Petrotomics Company

Reference: Modification of License Condition No. 11 - Source
Material License SUA-551 (Housekeeping Items)

LICENSE CONDITION NO. 11
SUMMARY

Revised: October 1996

Figure 5.1-1

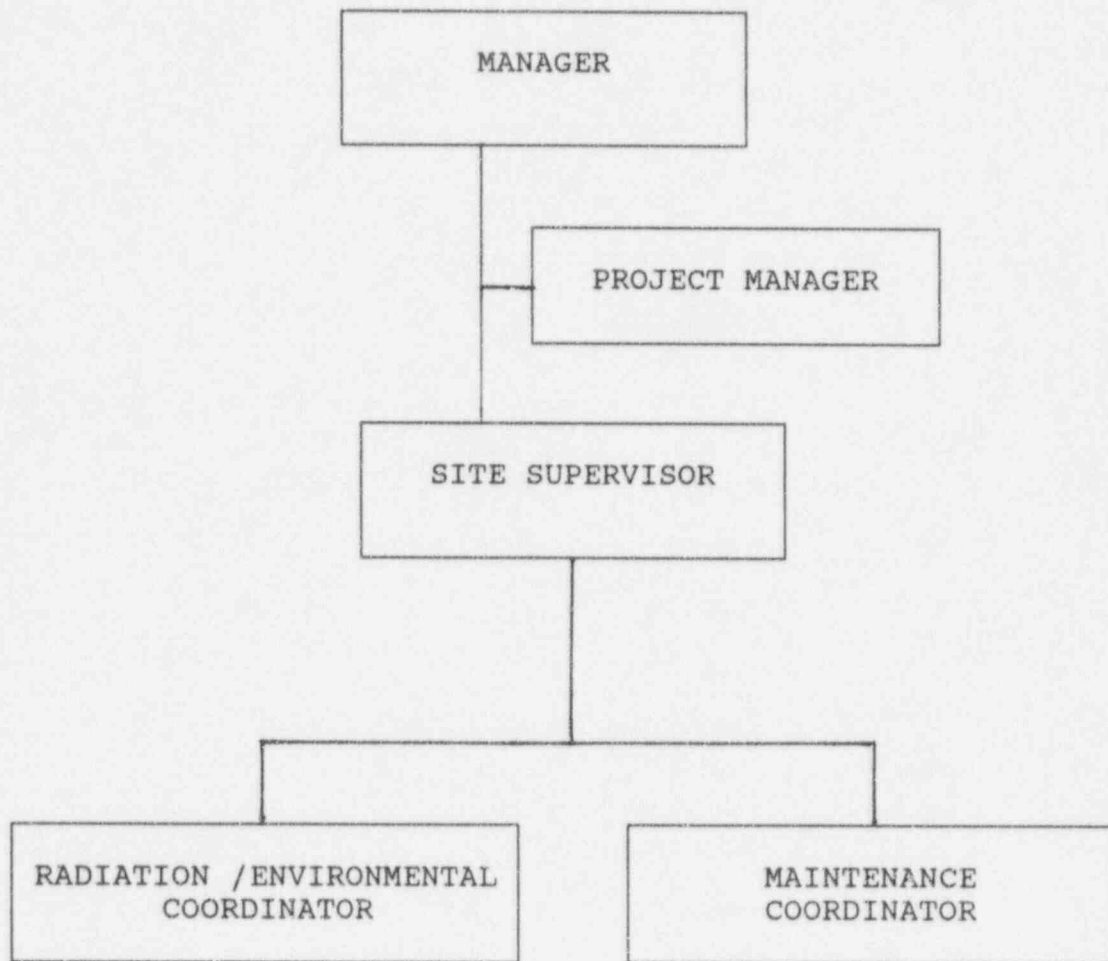
Figure 5.1-1 (organizational chart) was changed to reflect the current status.
